Re: Home2 Suites By Hilton – PL2024097 Response Letter

This letter is in response to the Commercial Final Development Plan Applicant's Letter dated May 17, 2024. The engineering plans have been revised to address the comments. The original comments are below and follow the order as shown in the review comments. Our responses are in bold, and follow each individual comment.

Project Name: Home2 Suites  
Project Address: 251 NE Alura Way, Lee's Summit, MO 64086  
Plan Number: PL2024097

AS-102

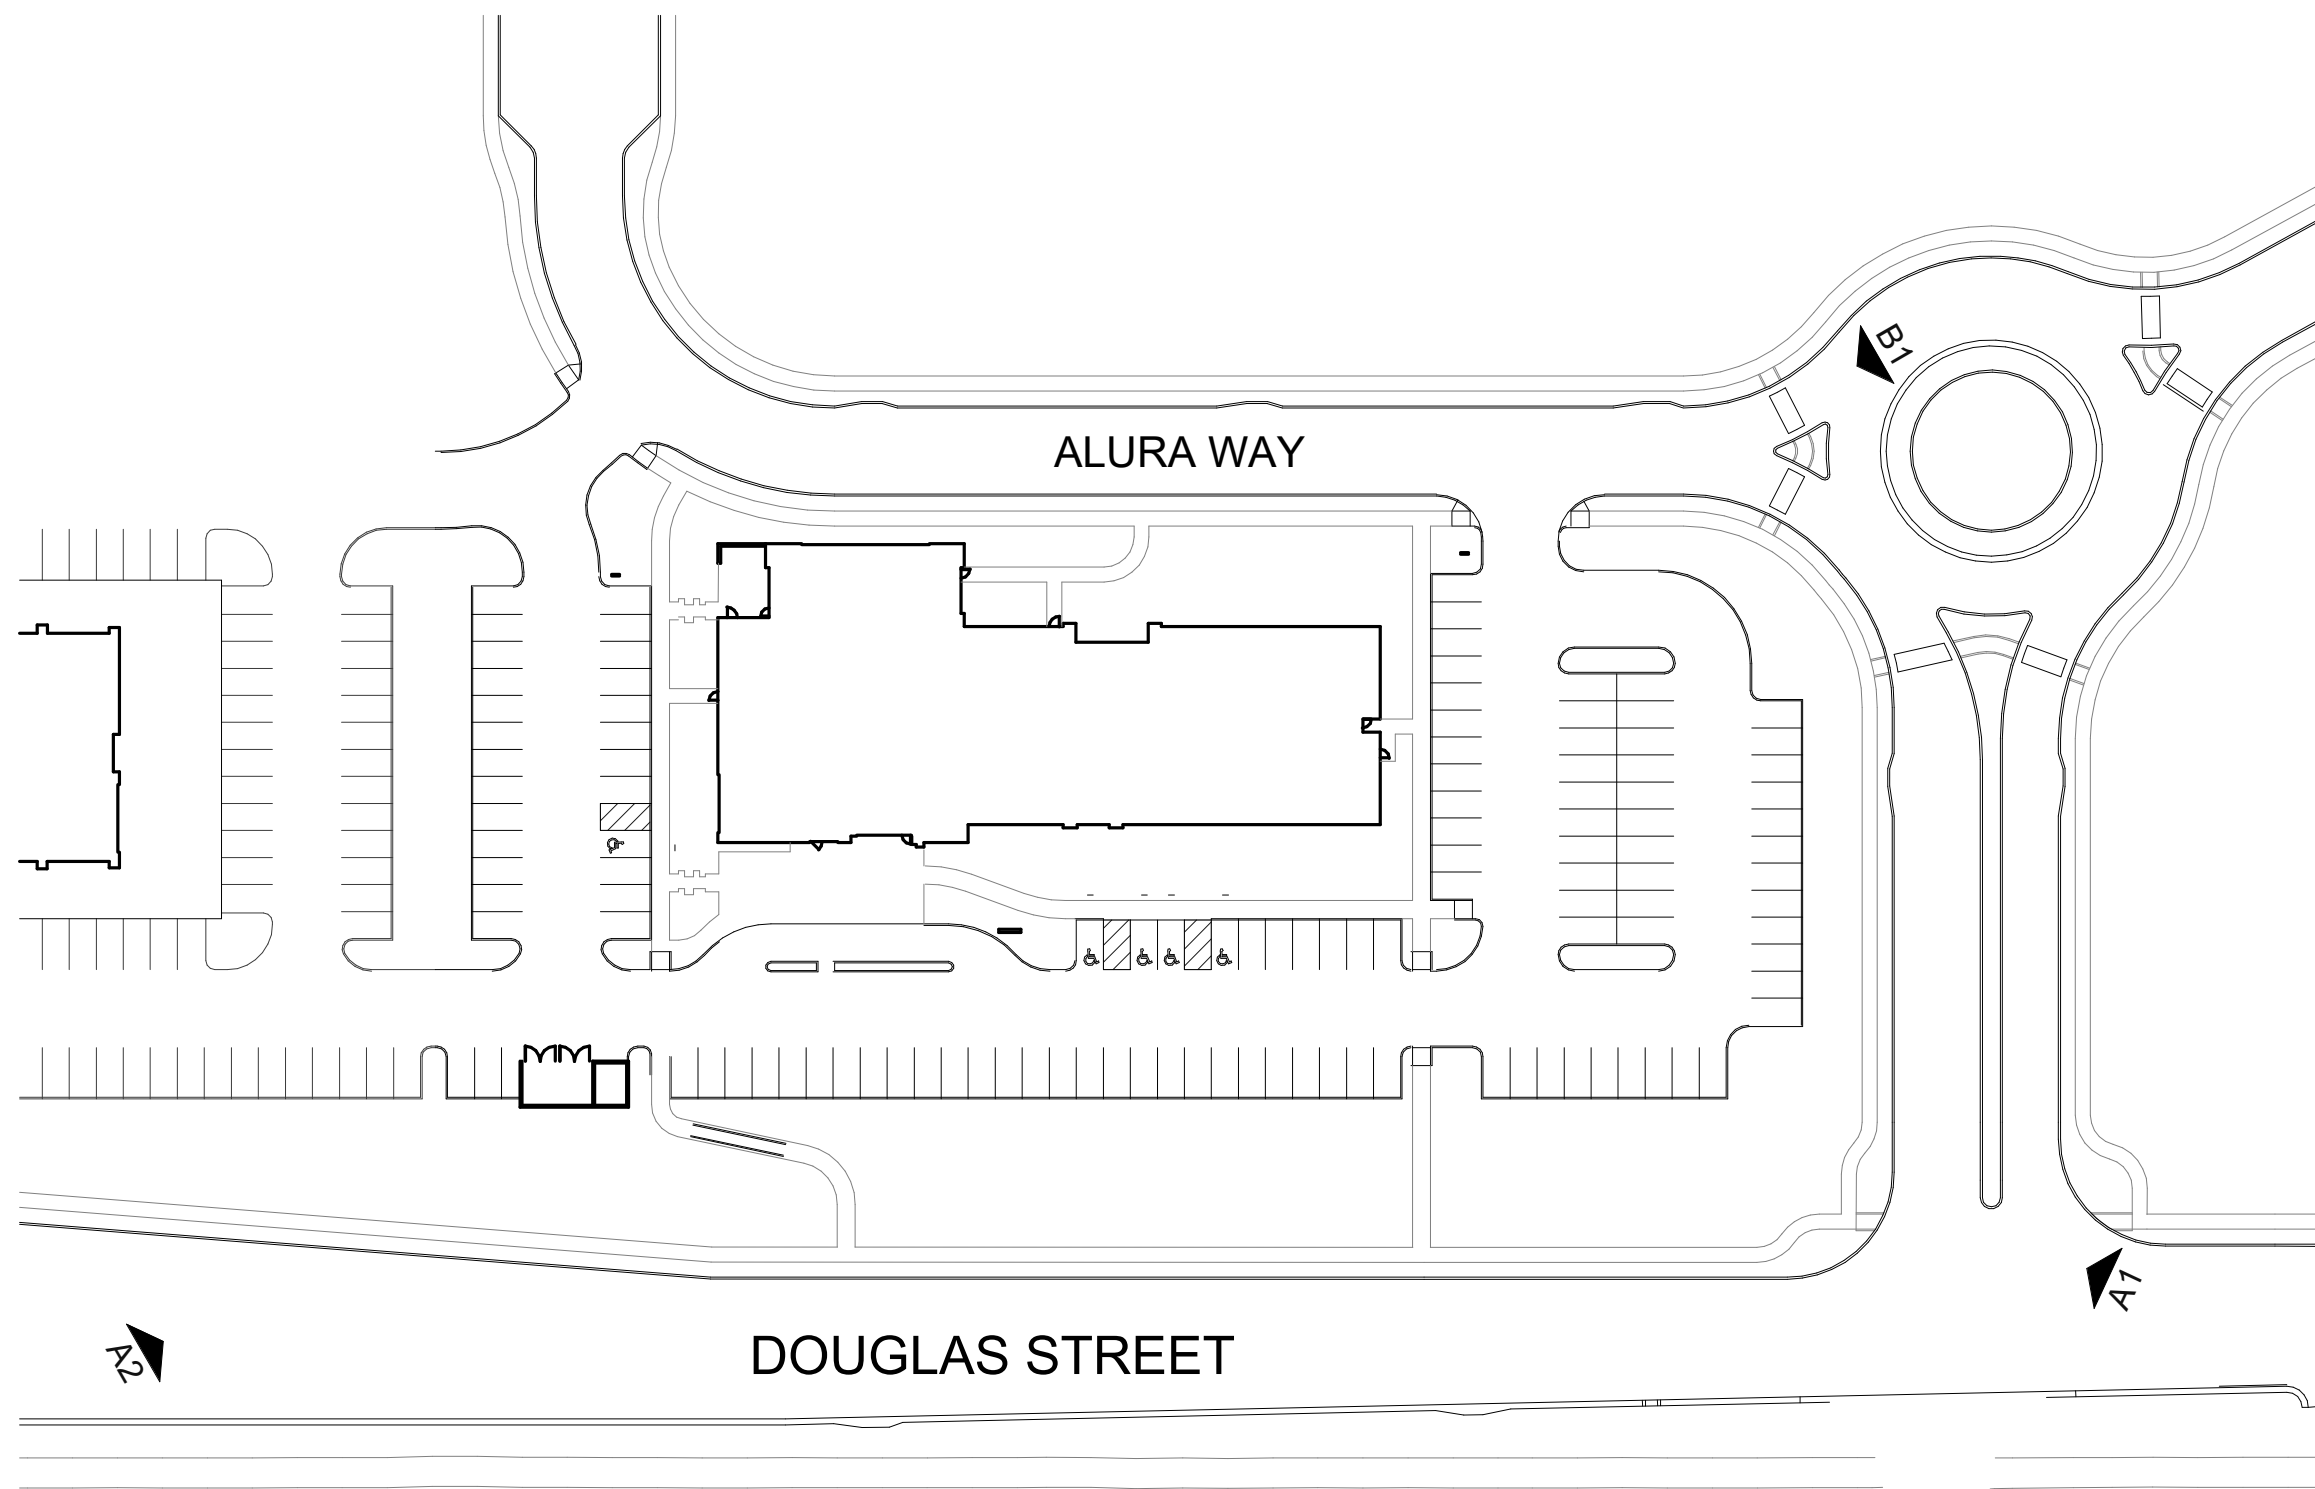
4. MECHANICAL SCREENING. Dash in the RTUs on the architectural building elevations (Sheets A-202 and A-203) to verify compliance with the requirement that all RTUs are fully screened from view on all sides by the use of parapet walls of a height at least equal to the units being screened. Take into account the added height from the curbs on which the RTUs will sit.

7. TRASH ENCLOSURE. Provide a detail of the proposed trash enclosure. Each trash enclosure shall be constructed of masonry walls or steel architecturally designed walls with either a solid steel opaque gate painted to be compatible with the color of the masonry or steel walls and building it is to serve or a steel framed semi-opaque gate with a screen mesh material approved by the Director that provides an appropriate visual barrier.

**Per discussions with Hector Soto on Friday May 10, parapets do not necessarily have to match the height of the rooftop mechanical equipment if it can be demonstrated through the use of sight line studies that the roof mounted mechanical equipment is not visible from the public right-of-way, most importantly the equipment is to be screened from view when along Colbern and Douglas.**

**Per the exhibit on sheet A-204, all roof mounted mechanical equipment on the 4-story roof is screened from view without the need of parapet revision.**

**The mechanical equipment on the west side of the building on the 1-story roof is naturally screened from Colbern and Douglas given the building geometry, however, curb mounted mechanical screening is being proposed to screen that equipment from Alura Way and the adjacent hotel unit windows.**

**See trash enclosure details on sheet AS-102.**

## SOUTH ENTRANCE-RIGHT IN

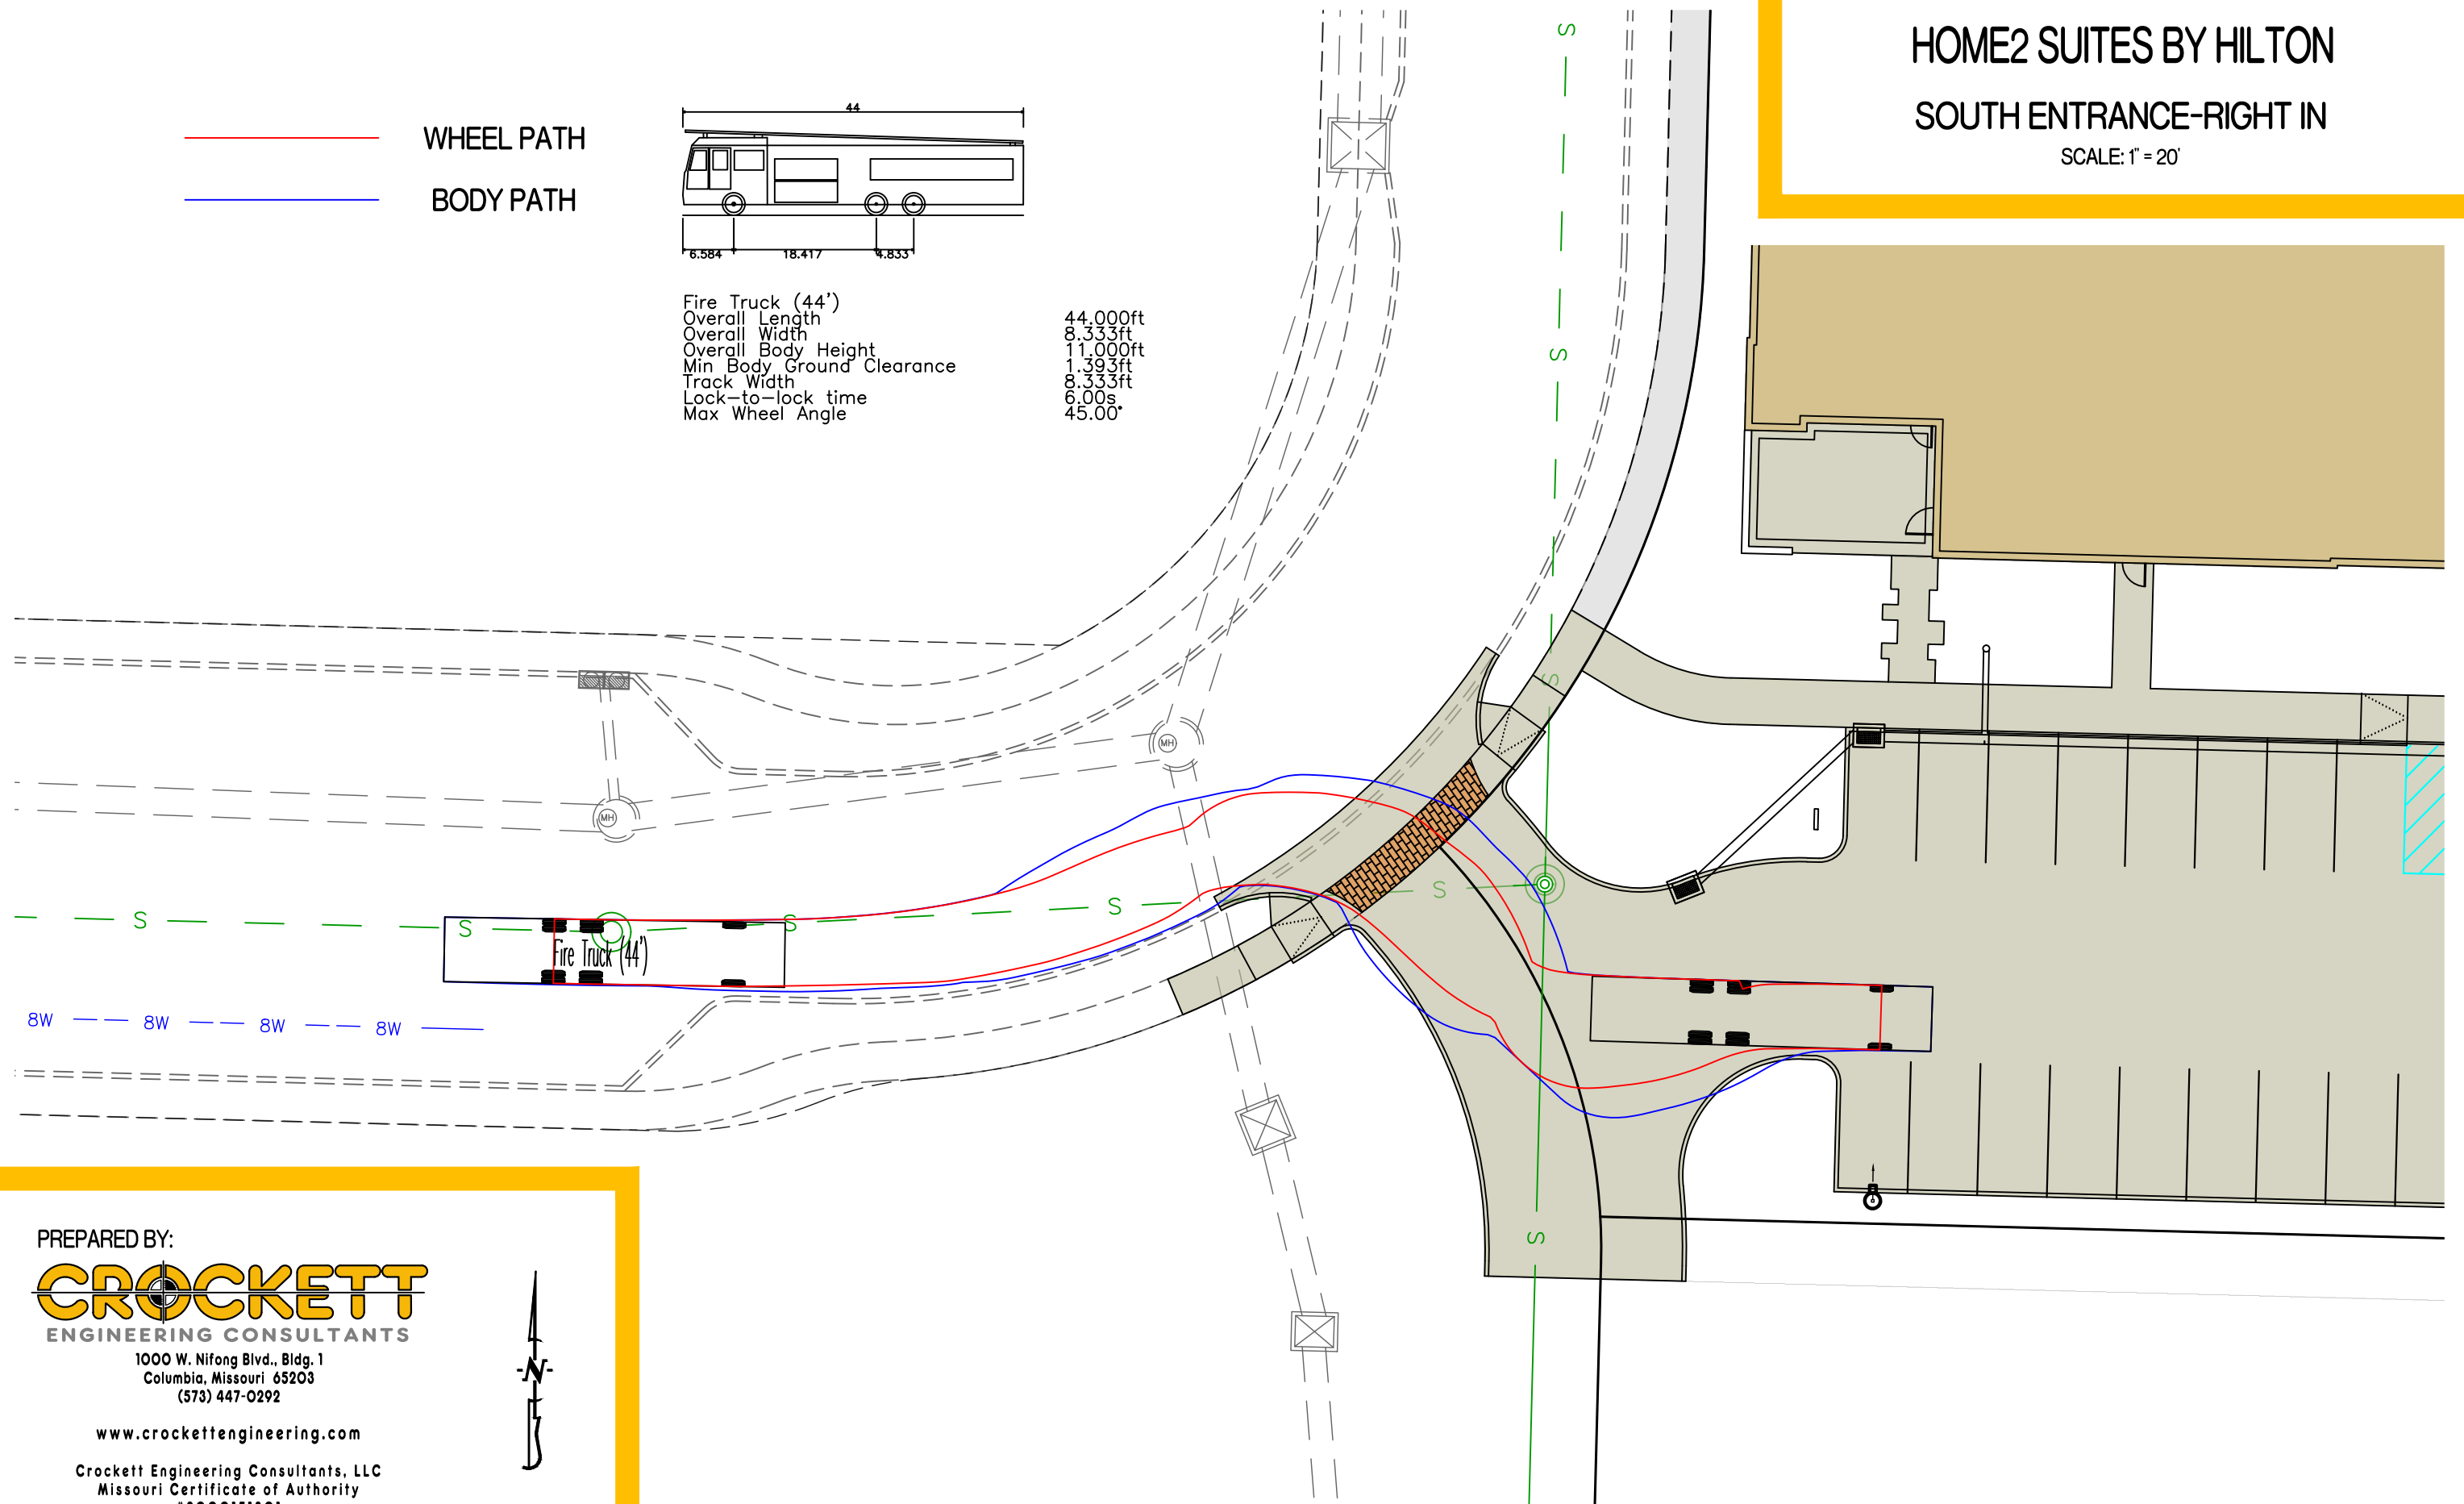
1. The current radii do not meet the City's design criteria for Commercial/Industrial Collector or Local roads. If you are not able to adjust the radii due to storm or other public site restrictions an exception may be allowed, otherwise site approval will not be given to the current design.

Please see attached revised exhibits. A 15' radius will still allow a firetruck to enter and exit these locations without bumping into the proposed curb. The red line shows the wheel paths of each movement shown.
